Appendix Ic of RNTPC  
Paper No. A/STT/26B

**Application for Planning Permission for  
Proposed Filling of Ponds for Permitted Innovation and Technology Hub (including  
Permitted Cargo Handling and Forwarding Facilities, Creative Industries, Eating Place,  
Flat (Staff Quarters only), Industrial Use, Information Technology and  
Telecommunications Industries, Office, Public Utility Installation, Research, Design and  
Development Centre, Shop and Services, Warehouse (excluding Dangerous Goods  
Godown)) at Lot No. 764 RP (Part) in D.D.99, San Tin, Yuen Long, N.T.**

(Application No. A/STT/26)

**Table 1: Responses to Comments from Government Departments on Planning Application No. A/STT/26 (21 January, 2026)**

Figure 2 Indicative Location of the Identified Recognized Sites of Conservation Importance and Key Ecological Resources within the 500m Assessment Area

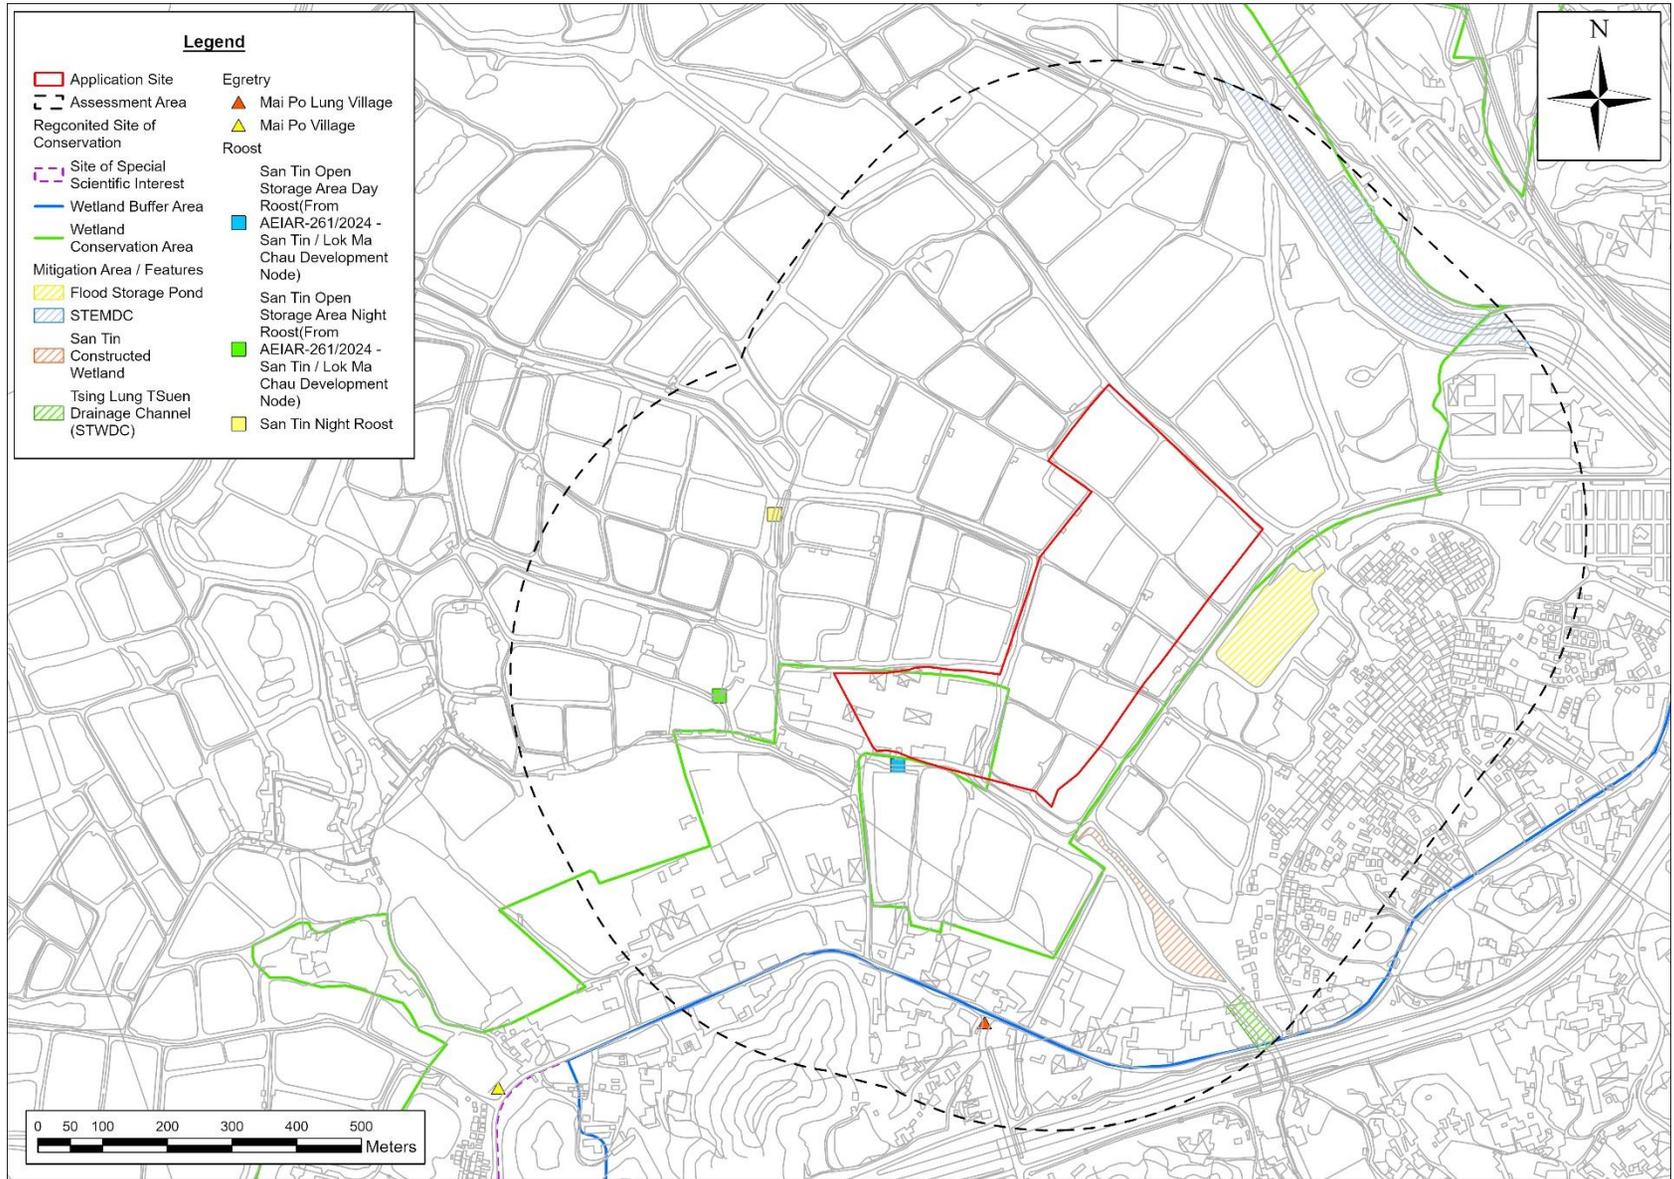
S.2.2, S.4.3 & Figure 2

Figure 3 Proposed Transects and Sampling Points for Ecological Surveys

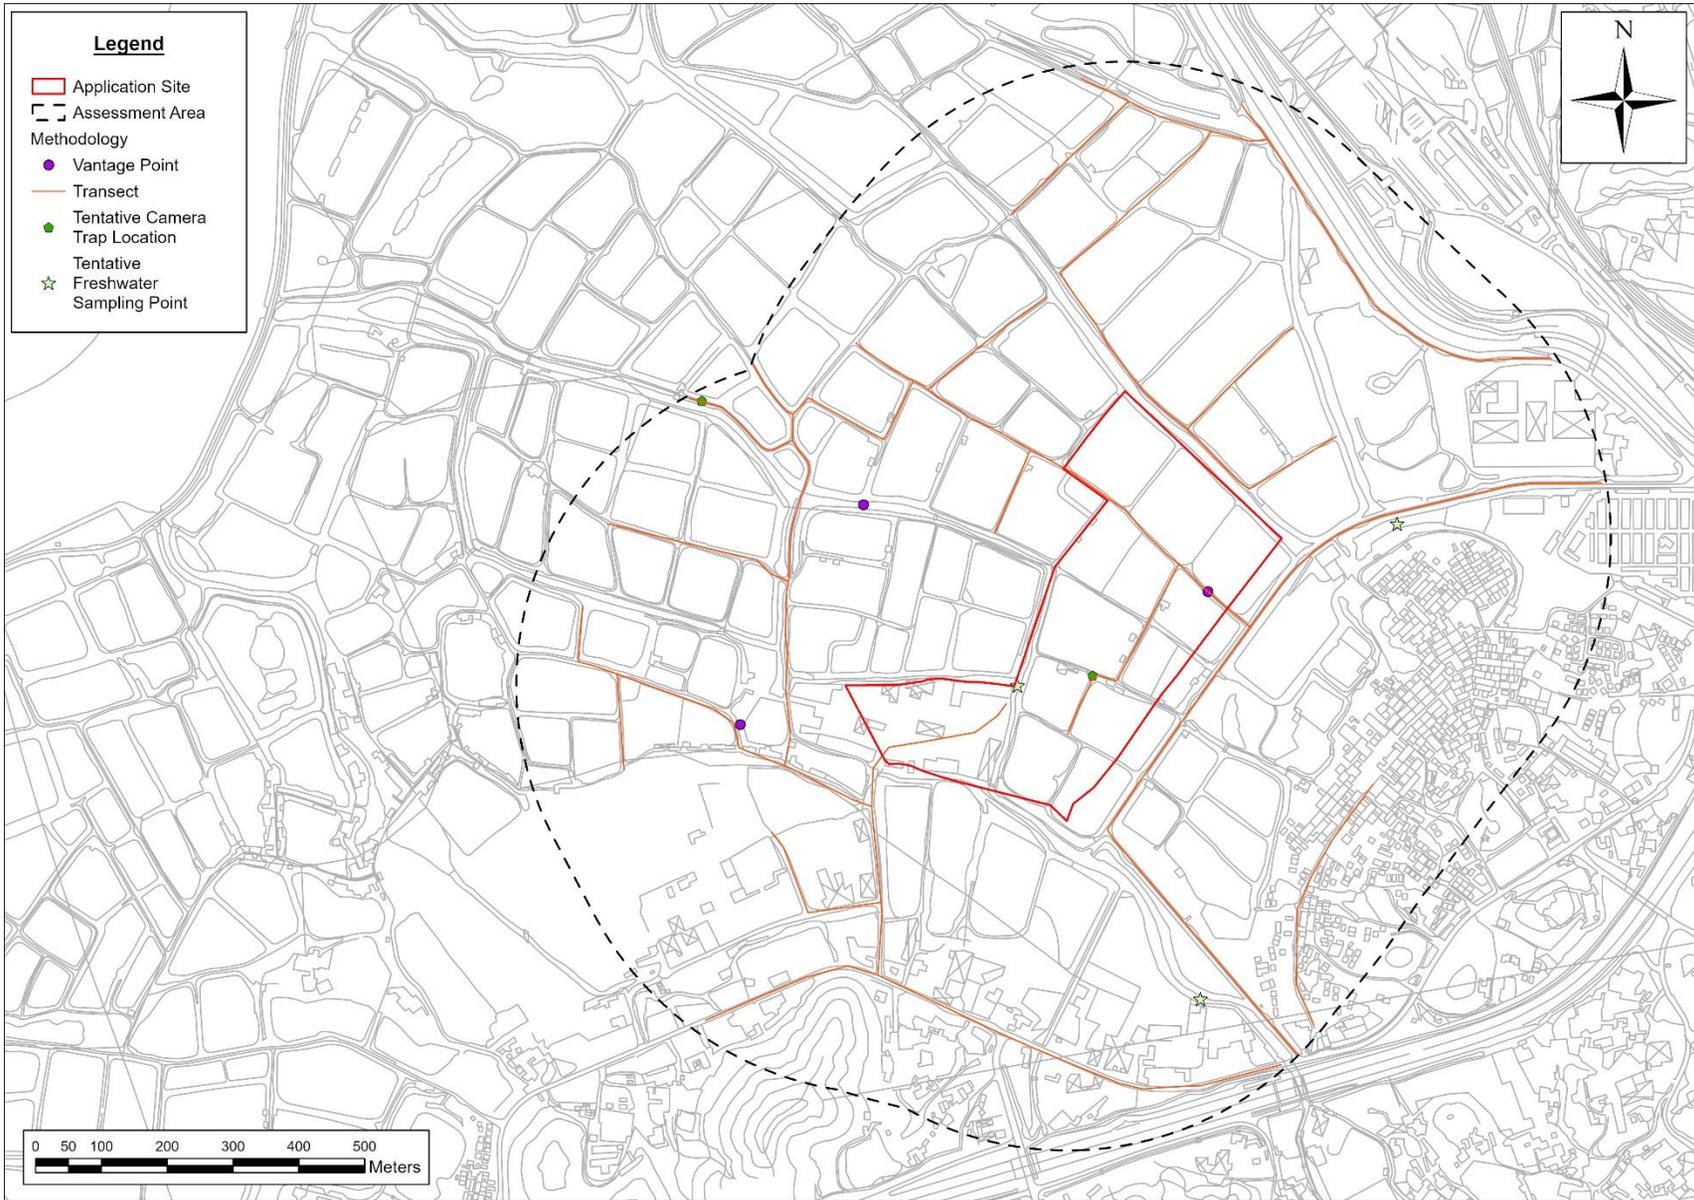
Figure 3

## **Annex H6 - BREEZEWAYS/AIR PATHS**

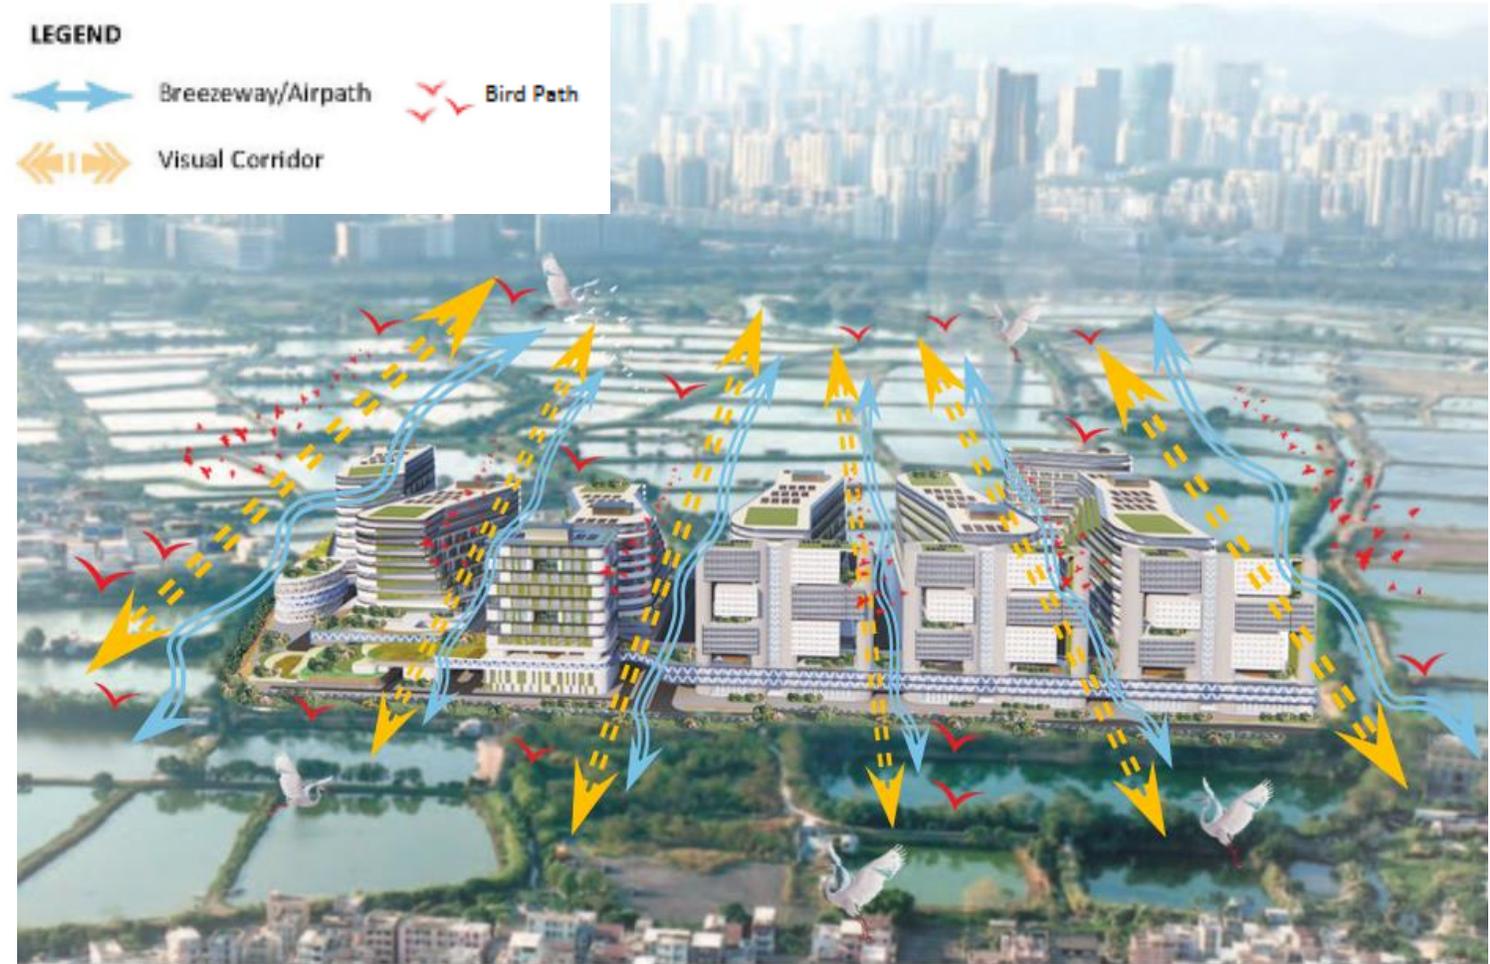
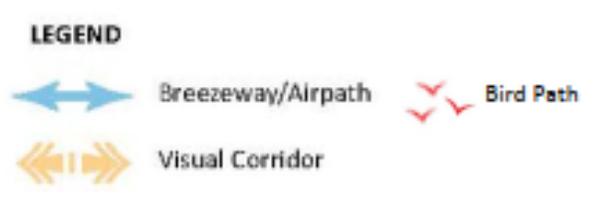
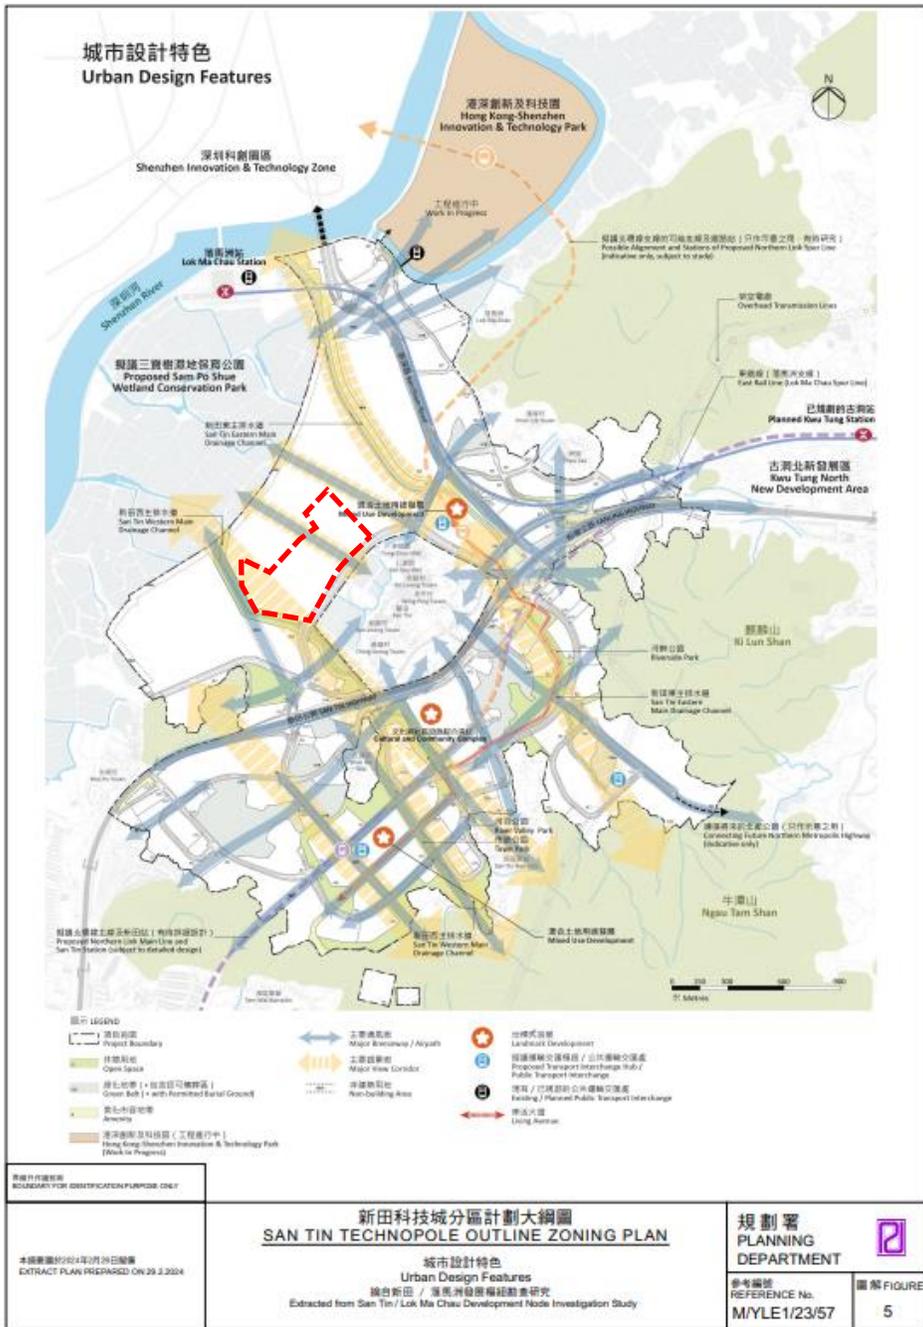
<p>18. According to the explanatory statement of the approved San Tin Technopole Outline Zoning Plan No. S/STT/2, provision of at least two effective breezeways/ air paths aligned in northwest to south-east direction across Area 19B is recommended. Hence, two 15m-wide NBAs are required under the endorsed Planning and Design Brief (full document available in the public domain). Please clarify if the required breezeways/air paths would be provided.</p>	<p>18. The recommended breezeways / air paths will be provided in accordance with the Explanatory Statement of the approved San Tin Technopole Outline Zoning Plan No. S/STT/2 and the endorsed Planning and Design Brief.</p> <p>The proposed development incorporates a total of six breezeways across the site, exceeding the minimum requirement of two 15 m-wide non-building areas (NBAs). These breezeways are generally aligned in the northwest–southeast direction to facilitate effective air ventilation across Area 19B. Refer to rendering <b>Annex H6</b> and <b>Annex H5-1</b> for the separate distance.</p> <p>The breezeways have been strategically planned with consideration of</p>

COMMENTS	RESPONSES
	<p>multiple design requirements, including ecological bird movement corridors, visual permeability, building separation, and safe and efficient circulation for container trucks and internal roads. At ground level, the breezeways provide a minimum clear width of approximately 19 m, with building separation ranging up to approximately 60 m through a step-terraced building design.</p> <p>The provision of multiple, wider-than-required breezeways enhances site permeability, improves micro-climatic performance, and ensures full compliance with the planning and urban design requirements of the OZP</p>
<p>19. Clarifications of the Applied Uses (a) Public Utility Installation</p>	<p>19. (a) The proposed PUI includes a cooling centre and a substation, which will provide utility services to the proposed I&amp;T Hub and support the government's development of the San Tin Technopole.</p>
